**Subject: MHI's Response to US-APWR DCD RAI No. 383-3002 REVISION 1**

Response to Request for Additional Information  
No. 383-3002 Revision 1

**RAI NO.:** NO. 383-3002  
**SRP SECTION:** 10.04.06 - CONDENSATE CLEANUP SYSTEM  
**APPLICATION SECTION:** 10.4.6  
**DATE OF RAI ISSUE:** 06/08/2009

Fig. 4 Na concentration vs crevice pHt when Na alone increases  
(Concentration rate = 10<sup>5</sup>)

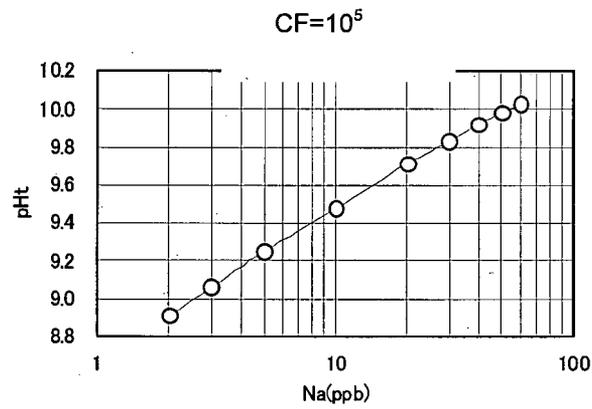
**Sodium.** Fig. 3-4 indicates  $\text{pH} \geq 10$  when  $\text{CF} \geq 107$  (using the bulk concentration of 1 ppb from Table 3-1). Hence, for  $\text{CF} = 105$  as claimed by applicant, the analogous bulk concentration would be 100 ppb, which is less stringent than applicant's value of 50 ppb for a limit.

Fig. 4 shows the Na concentrations when Na alone increases under the condition of concentration rate of  $10^5$  vs the crevice pHt (evaluation code calculation result). The crevice pHt thereby would be 10 or more at Na concentration of 50 ppb or more. Therefore, the value of 50 ppb is set as the control upper-limit value for Na concentration in the operation mode of less than plant load 30%.

Fig. 5 SO<sub>4</sub> concentration vs crevice pH when Na co-exists (Concentration rate = 10<sup>5</sup>)

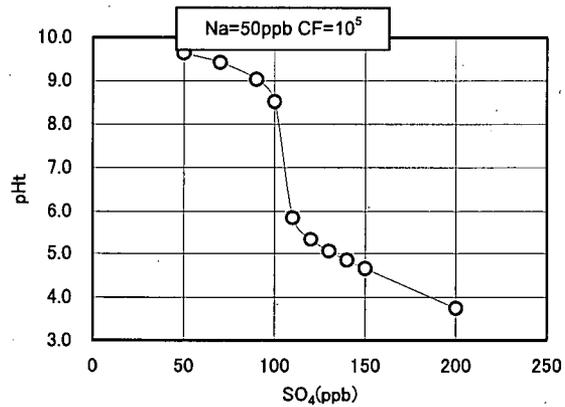
**Sulfate.** Fig. 3-7 indicates  $\text{pH} \leq 5$  when  $\text{CF} \geq 106$  (using the bulk concentration of  $3[\text{Na}] = 3$  ppb from Table 3-1). Hence, for  $\text{CF} = 105$  as claimed by applicant, the analogous bulk concentration would be 30 ppb, which is more stringent than applicant's value of 100 ppb for a limit.

Fig. 5 shows the behavior of crevice pHt (evaluation code calculation result) when  $SO_4$  concentration is increased while 50 ppb of Na co-exists under the condition of concentration rate of  $10^5$ . If  $SO_4$  concentration becomes 100 ppb or more, thereby, crevice pHt drops rapidly to 5 or less. Consequently, 100 ppb is set as the control upper-limit value for  $SO_4$  concentration in the operation mode of less than plant load 30%.

Fig. 6 Cl concentration vs crevice pH when Na co-exists (Concentration rate = 10<sup>5</sup>)

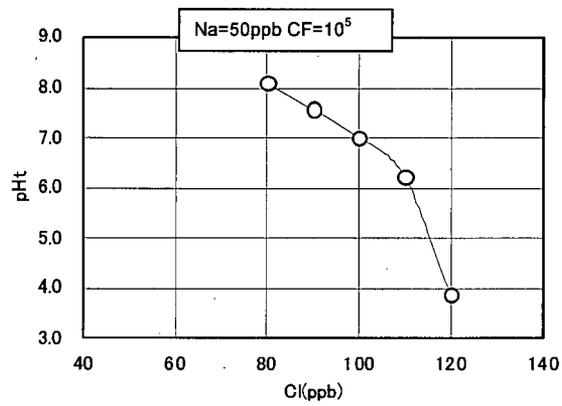
**Chloride.** Fig. 3-6 indicates  $\text{pH} \leq 5$  when  $\text{CF} \geq 2.5 \times 10^5$  (using the bulk concentration of 4.6 ppb from Table 3-1). Hence, for  $\text{CF} = 105$  as claimed by applicant, the analogous bulk concentration would be 10 ppb, which is much more stringent than applicant's value of 100 ppb for a limit.

Fig. 6 shows the behavior of crevice pHt (evaluation code calculation result) when Cl concentration is increased while 50 ppb of Na co-exists under the condition of concentration rate of  $10^5$ . If Cl concentration becomes 100 ppb or more, thereby, crevice pHt drops rapidly to 5 or less. Cl, on the other hand, affects the drop of crevice pHt, and Cl itself provides causes of pitting in its co-existence with oxidizing agents. Concentration, in which Cl does not affect the materials of SG heat transfer tube soundly, is 100 ppb as shown in Fig. 7 (Reference 3). From the viewpoint of preventing the occurrence of these damages, 100 ppb is set as the control upper-limit value for Cl concentration in the operation mode of less than plant load 30%, by reflecting both conditions.
